ALTERATION TO A HISTORIC PROPERTY STAFF REPORT

Site: 45 Walnut Street c. 1890 Louville Niles House Case: HPC 2013.060 Single Building District

Legal Notice: Replace driveway material

Case #: HPC 2013.060

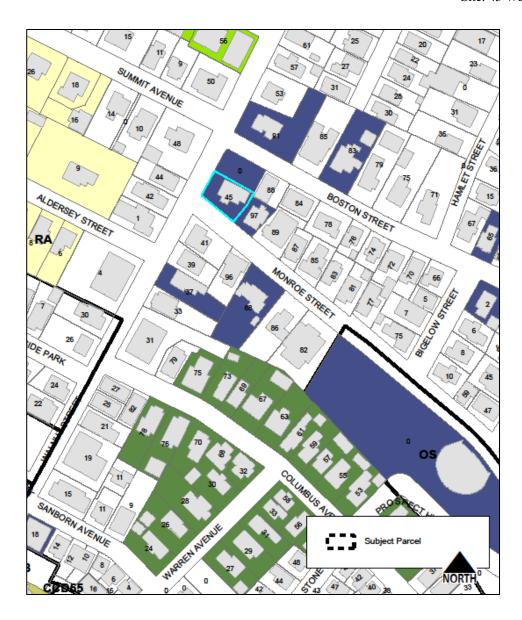
3. The existing landforms of the site should not be altered unless shown to be necessary for maintenance of the structure or site. Additional landforms will only be considered if they will not obscure the exterior of the structure.

The re-grading is necessary for the maintenance of the structure. The re-grading will also help preserve the house from further water damage to its foundation.

4. The original layout and materials of the walks, steps and paved areas should be maintained if significant grade changes constitute an important feature of the structure or site. Consideration will be given to alterations if it can be shown that improved site circulation is necessary and that the alterations will accomplish this without altering the integrity of the structure.

No changes to the features described in the Form B will be altered. The proposed salvaged posts and re-graded driveway will not obscure any part of the original structures. The circulation pattern will not be altered.
